TECHNICAL SALES BULLETIN

DOCUMENT NUMBER:	TSB 01-22
REVISION:	A
DATE:	6/8/23
PAGE NUMBER	1 OF 2

BLIND BOLT DRIVE ANVIL FINISHES

DRIVE ANVILS, UAB™ BLIND BOLT

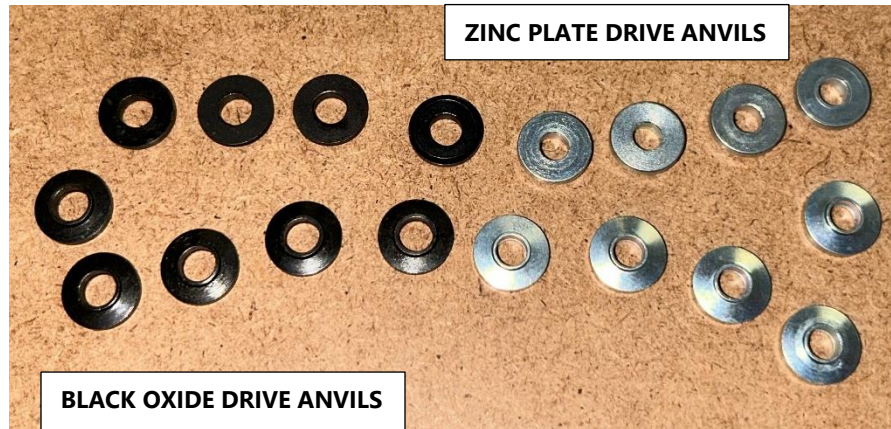
HFS Tucson determined that a zinc plated drive anvil is a preferred finish over the previously used black oxide and has therefore implemented this change in the manufacturing process.

As a result of the change to a zinc plate, product may be seen with drive anvils that are either black or clear silver in appearance. See page two for photographs.

It should be noted this change has no effect on the functionality of the fastener whatsoever. No changes were made to the fasteners with the conversion to zinc plated drive anvils.
